Access Compliance Report

Public Rights-of-Way

(Curb Ramps)

Intersection ID: 43869	Main Street: CALDWELL_RIDGE_PY	Cross Street: SIDNEY_CREST_AV	Location: NE
ADA ID: 5D66FF095B62	Ramp Type: Perp	Initial Pass/Fail: Fail	Overall Compliance: No
Severity Score: 33.75			
Codes/Mitigation Info/Possible Solution		Field Measurements/Component Compliance

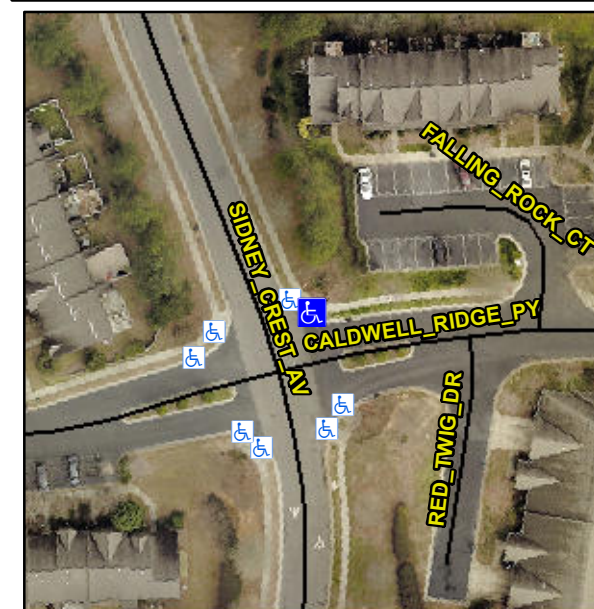
Not Found, R304.5.1, R304.5.3

Compliance	Description	Data	Compliance	Description	Data
N/A	Ramp Length (in)	46.5	Yes	Ramp Slope (%)	6.1
No	Ramp Width (in)	41.5	No	Ramp XSlope (%)	10.0
N/A	Flare Type LT	N/A	N/A	Flare Type RT	N/A
N/A	Flare Slope LT (%)	N/A	N/A	Flare Slope RT (%)	N/A
N/A	Flare Traversable LT?	N/A	N/A	Flare Traversable RT?	N/A
N/A	Landing Length (in)	N/A	N/A	DWS Provided?	N/A
N/A	Landing Width (in)	N/A	N/A	DWS Contrast?	N/A
N/A	Landing Slope (%)	N/A	N/A	DWS Length (in)	N/A
N/A	Landing X Slope (%)	N/A	N/A	DWS Full Width?	N/A
N/A	Landing Curb? (Y/N)	N/A	N/A	DWS Offset (in)	N/A
N/A	Shared Landing?	N/A			
N/A	Gutter Ponding?	N/A	N/A	Gutter Slope (%)	N/A
N/A	Gutter Lip Ht (in)	N/A	N/A	Gutter X Slope (%)	N/A
N/A	Painted X Walk1?	No	N/A	Painted X Walk2?	N/A
	X Walk 1 Direction	To S		X Walk 2 Direction	N/A
N/A	X Walk 1 Width (in)	N/A	N/A	X Walk 2 Width (in)	N/A
	X Walk 1 Slope (%)	6.1		X Walk 2 Slope (%)	N/A
	X Walk 1 X Slope (%)	2.2		X Walk 2 X Slope (%)	N/A

Remove & Replace Entire Ramp.
